FINAL RECOMMENDATION OF THE NORTHEAST DESIGN REVIEW BOARD

Project Number: 3011405

Address: 324 NE 45th St

Date of Meeting: Monday, February 24, 2014

PERSPECTIVE VIEW FROM THE SOUTHEAST

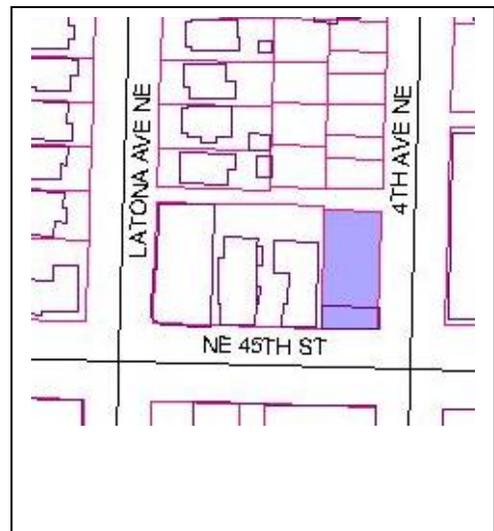
At the Final Recommendation Meeting, the Board indicated they were satisfied with the design response presented on plan pages 1, 11-14, 34-37, 53 and 55, including 'layered canopies' on the south and east facades. They also noted that fenestration and interior floor plans treatments are a good illustrated how departures can result in a better design.

1. (SMC 23.54.030 B.2.a. REQUIRED PARKING):

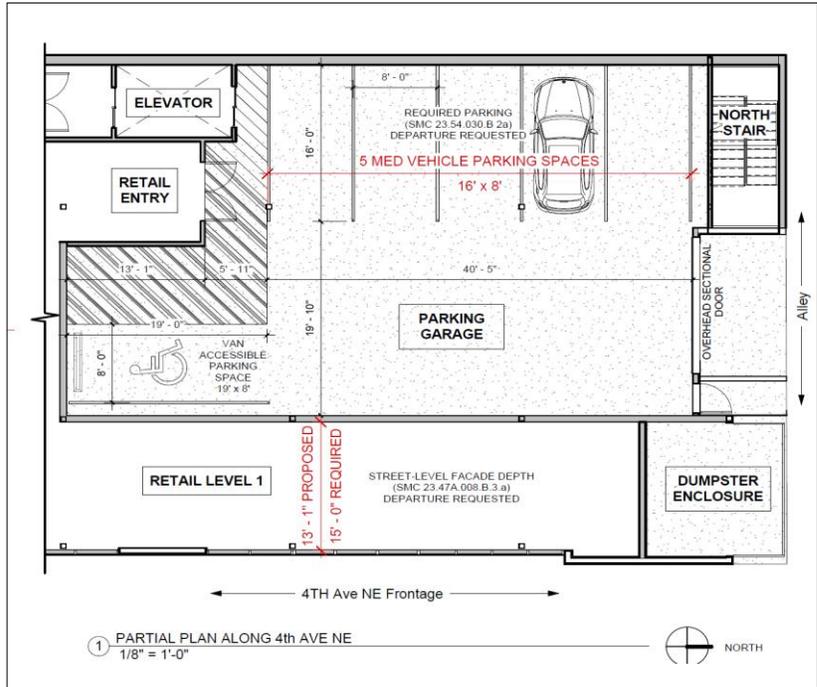
The applicant proposes five parking spaces for medium vehicles and one van accessible space.

JUSTIFICATION Due to the narrowness of the site and the desire to use the retail frontage of the building to screen the parking area, it is not possible to accommodate large stall parking. The project is also requesting a reduced façade depth along 4th Ave NE to accommodate both parking and retail space.

The Board indicated they were favorable towards the departure given the number customers who drive to this business and the availability of parking on 4th Ave NE.

3. (SMC 23.47A.008 B.3.b. STREET-LEVEL DEVELOPMENT STANDARDS): The Code requires Nonresidential uses at street level shall have a floor-to-floor height of at least 13 feet. The

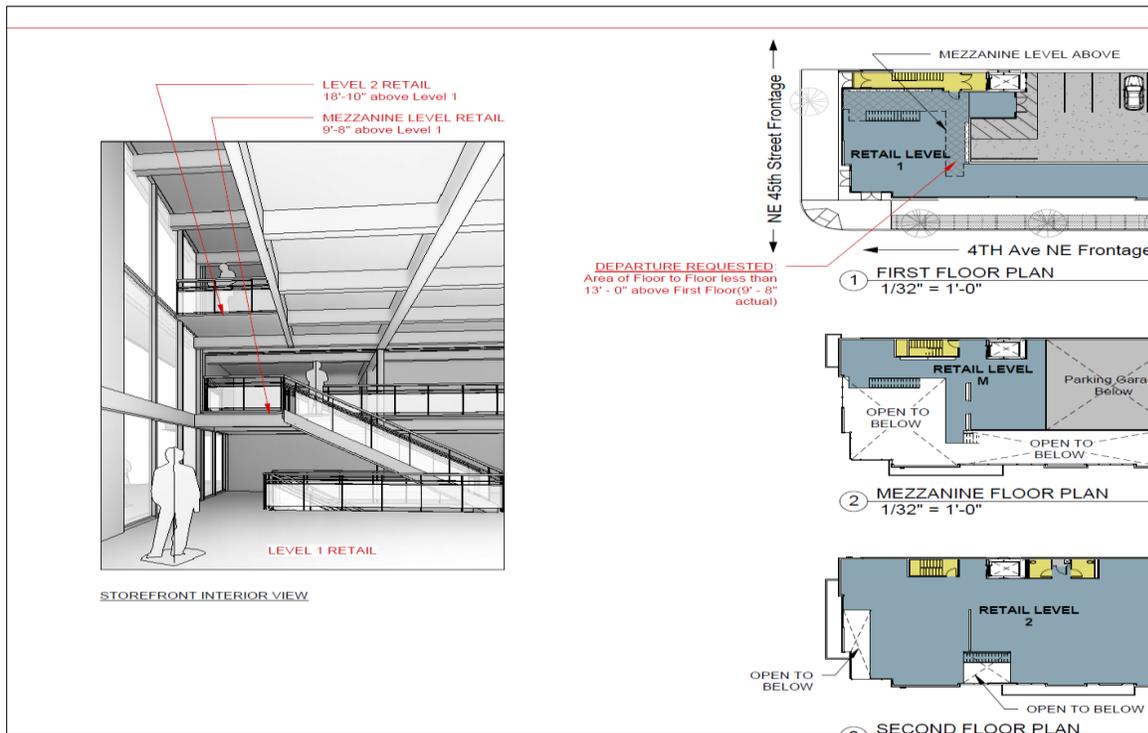
applicant proposes a departure from 13 foot floor-to-floor height was requested for the portion of the ground floor with a mezzanine is pursuant to SMC 23.41.012 B.2.

JUSTIFICATION The mezzanine functions as a catwalk feature that activates the street frontage and provides a spatially interesting visual pedestrian pathway from the street level retail displays to the upper floor retail display. It maintains the visibility of the retail use and promotes ‘eyes on the street’ encouraging pedestrian activity on NE 45th St while inviting shoppers to visit the retail establishment. As both the mezzanine and the main floor (which contains the mezzanine) are both used for the same sales and retail display function — the entire volume would be perceived a one space. The applicant proposes that this arrangement meets the intent of the code to provide a tall, activated retail space facing the street.

The Board indicated they were favorable towards the departure — the interior floor plan and the exterior design elements maintain a visible retail use that encourages pedestrian activity on NE 45th St and 4th Ave NE.
